Re: Response to DOE Comments and Additional Comments on NRC's Safety Evaluation
Report of UNC License Amendment Request dated September 24, 2018
Church Rock Mill Site, Gallup, New Mexico
NRC Source Material License SUA-1475

Attachment I – Response to DOE Office of Legacy Management’s (LM) Comments on SER

Attachment II – UNC Comments on SER

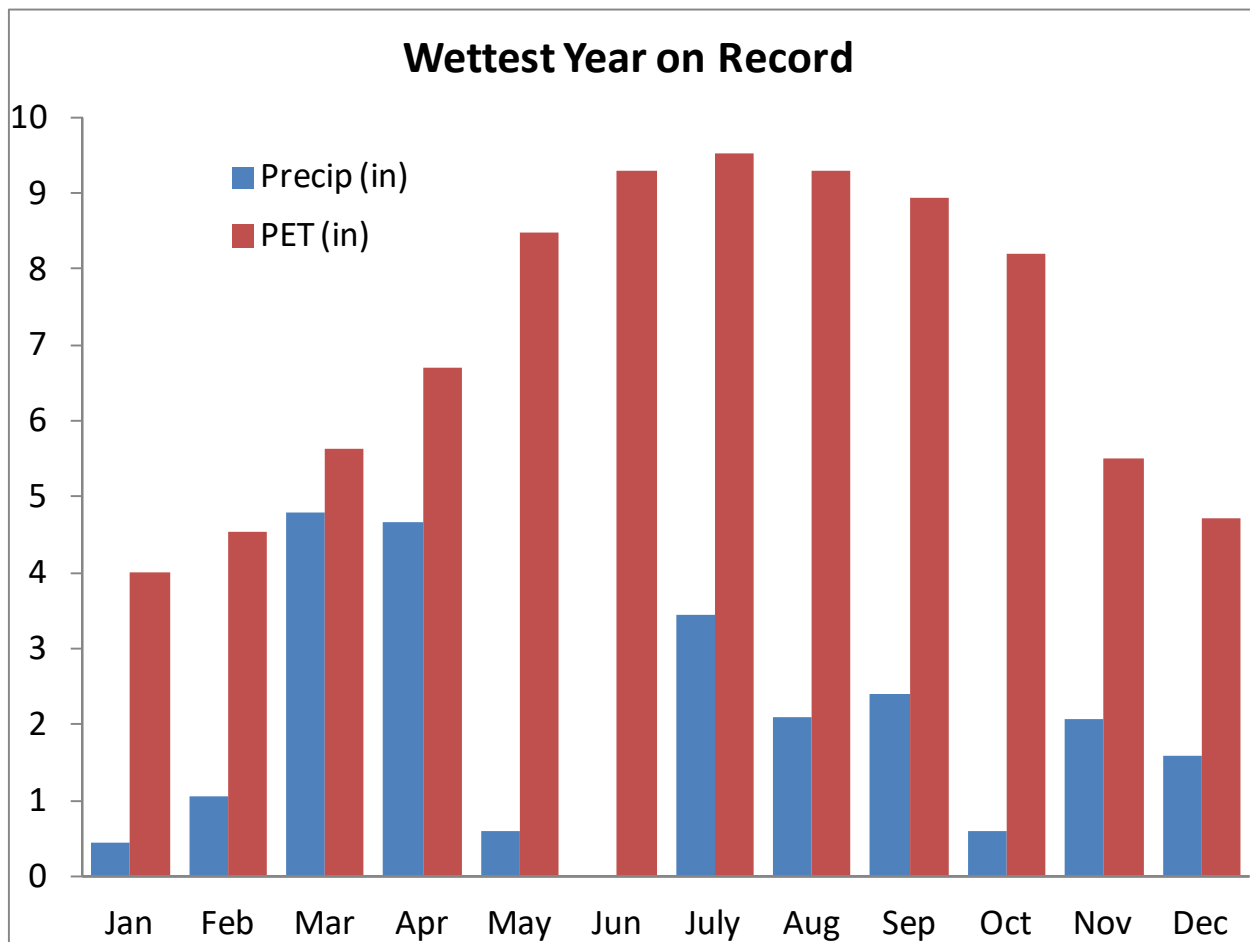
Sensitivity analysis for UNSAT-H model simulations could be performed to include absolute worst-case scenarios to determine parameter values needed to reach the threshold of net seepage into mine waste and mill tailings. Such worst-case model parameters could include:

- a) The seasonality of precipitation. “less than half of the annual precipitation occurs during the summer months when PET is highest.”
 - i. It is unclear if antecedent soil moisture conditions from the melting of snowpack, and subsequent early spring rainfall during low PET times of year, under worst case conditions were considered in the sensitivity analysis. It does not appear that such model output was reported.

- ii. If not, LM recommends a more conservative UNSAT-H model simulation be considered, on an annual time scale, to account for incremental worst-case scenario antecedent soil moisture conditions under snowpack and spring rains when PET is low.

UNC Response to 5a: there is no specific performance criteria associated with water balance per 40 CFR 192. Given this, the point of diminishing returns (PODR) method summarized in *Dwyer, SF, R Rager, J Hopkins. 2007. Cover System Design Guidance and Requirements Document. Los Alamos National Laboratory report LA-UR-06-4715 and U.S. Environmental Protection Agency (USEPA), 2012. Closing Small tribal Landfills and Open Dumps. How to Design Environmentally Safe Covers Including Additional Design Guidance for Arid Regions. EPA Design Guidance EPA-909-R-11-007* was utilized. This method identifies the cover depth required to minimize flux. This method included all potential input parameters, boundary condition, and profile variability. Well over 100 sensitivity analyses were performed to evaluate potential changes in soil hydraulic properties, vegetation, and climate conditions, including antecedent soil moisture conditions from the melting of snowpack, and subsequent early spring rainfall during low PET times of year, under worst case conditions. All solutions for the vegetated ET cover system predicted no flux no matter how conservative the applied conditions. Table 1 provides a partial list of modeling sensitivity analyses performed and summarized in the *Cover System Design Report* (Dwyer, 2018). Also, there were additional analyses performed and presented in the *Consolidation and Groundwater Evaluation Report* (Dwyer, 2018)

Climate boundary conditions proved to be the most sensitive to the output. The climate was varied during the modeling simulations to include both typical and worst-case possibilities. Historical weather data for the Gallup, NM area and surrounding weather stations were evaluated from available historical data from 1897 to 2016. The average precipitation at the Gallup airport is about 11 inches per year (28 cm) per the Western Regional Climate Center (<http://www.wrcc.dri.edu/>). The typical model climate used an annual precipitation volume of 11.71 inches (29.74 cm). The precipitation is highest during July and August while the climate's demand for water, referred to as potential evapotranspiration (PET), is also highest during those months.

The most extreme climate year occurred in 1906 when the area received 23.8 inches (60.5 cm) of precipitation. This climate year was utilized as the most extreme weather in the computer simulations. This was not only the highest annual precipitation received on record, but the majority of the moisture came in March and April with significant moisture also received in February, November and December (see figure below). Much of this moisture came as snow or less intense rainstorms compared to the typical summer monsoons that produce high intensity storms and thus significant runoff. These months with high precipitation volume also had reduced PET due to their cooler temperatures, so this period was also the worst-case infiltration climate that the site has experienced during recorded history. To add conservatism, 1906 was modeled back-to-back in all computer simulations. This is a series of events that is beyond anything known to occur at this site. Furthermore, the precipitation was applied during the computer simulations at a rate less than the infiltration rate – essentially forcing all rainfall to infiltrate. This added additional conservatism in the modeling effort given that much of the precipitation at the site runs off before it can infiltrate into the cover system.

The beyond worst-case condition of the wettest year on record (more than double the average annual precipitation rate) two consecutive years applied with the majority of precipitation coming outside of the summer months was performed, including assuming no vegetation on the cover in multiple simulations. The precipitation was applied to allow for full infiltration and thus simulate the worst case infiltration event whether that is melting snow or a very slow and continuous precipitation event during a period when PET is reduced and transpiration is either reduced

Fig. 13: Suggested value of the retention criterion for granular filters, for a dense soil, interpolated between the hyperstable and mesostable cases. (The dashed line represents the classical retention criterion for granular filters, Equation 72.)

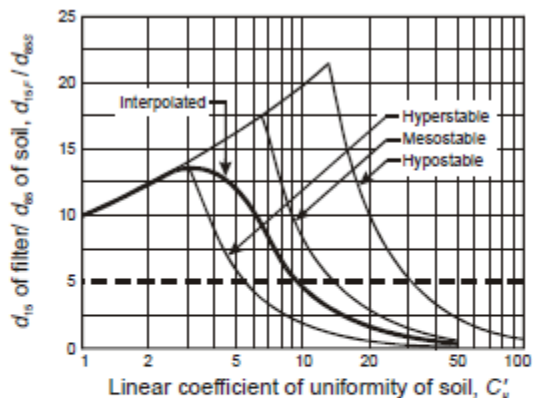
- c. Sheet 9-11, Mill Site Repository Area Stormwater Controls, Riprap Chute Details, Detail #2B, Typical Chute Riprap and Bedding Detail, and Appendix I, Attachment I.3, Filter Compatibility Calculations for Mill Site and Mine Site Stormwater Controls: There is a large gradation gap between the top filter layer and the 27-inch riprap. Our concerns are the interstitial velocities in the area of the hydraulic jump where the top filter layer could effectively become a wearing layer as particles are slowly removed. NUREG 1623 was used to design the filter at the bottom of the Pipeline Arroyo Chute. DOE does not believe that NUREG 1623 is the correct design guidance criteria for this application. DOE suggests you consider the following references as well: U.S. Department of the Interior, Bureau of Reclamation (BOR), 1987. Design of Small Dams <https://www.usbr.gov/pn/programs/ea/wash/potholes/techreport-alta-attachmentK.pdf> and Mishra, S.K., J.F. Ruff, 1998. Riprap Design for Overtopped Embankments. Final Report. Prepared for U.S. Bureau of Reclamation. https://www.usbr.gov/tsc/techreferences/hydraulics_lab/pubs/PAP/PAP-0809.pdf. Both could be useful.

UNC Response to 7c: The Stantec design document (Attachment I.3) presented an analysis of filtering capabilities between the top filter layer (Type II Filter) and the $D_{50} = 24$ -inch riprap material using the Terzaghi method which provides if the ratio of the D_{15} of the Riprap layer (D_{15r}) and the D_{85} of the Type II Filter layer (D_{85f}) is less than 5 then there will not be sufficient void space in the riprap layer for the sub-layer to wash through. This is consistent with recommendations in USBR (1987) (see Page 218 of the manual).

Table 3 of Attachment I.3 provides the computed ratio of the proposed materials is 4.92. This value is computed using average sizes within the material gradation limits presented in Table 1 and Table 2. From analyzing the extremes of the provided gradation limits, the maximum D_{15r}/D_{85f} that could occur within the specified gradation limits is 7.4. More recent research by J.P. Giroud (see reference below) notes the simplistic retention criteria (Terzaghi Criteria) does not account for the internal stability of the soil structure and that the actual threshold for soil stability as defined by D_{15r}/D_{85f} is not constant but rather varies with the coefficient of uniformity of the sub-layer. This is illustrated in Fig. 13 provided below taken from Giroud, 2003 which indicates the variable retention criteria suggested by Giroud using the thick solid line and constant retention criteria suggested by Terzaghi using the thick dashed line. The specified Type II material

coefficient of uniformities (defined by D_{60}/D_{10}) that could occur within the specified gradation limits of the Type II filter material is between 7.5 and 2.9. The interpolated curve (thick solid line) from Fig. 13 suggests D_{15f}/D_{85b} values of 7.5 or less will be stable within the range of potential Type II Filter material coefficients of uniformity. This finding by Giroud is supported by the testing completed by Mishra and Ruff (1998). This document presents results of tests on riprap materials of D_{50} =15-in, 26-in, 11-in. riprap materials placed over a filter bedding layer. The bedding materials used had a D_{50} between 1.5-in. and 1.9-in and a coefficient of uniformity of approximately 1.6. The filter compatibility between the tested riprap and bedding materials (i.e., D_{15f}/D_{85b}) is 3.5, 7.0, and 2.7 respectively. Even in the case where the D_{15f}/D_{85b} is equal to 7 (greater than 5) no washout of the bedding layer was reported in the test result findings.
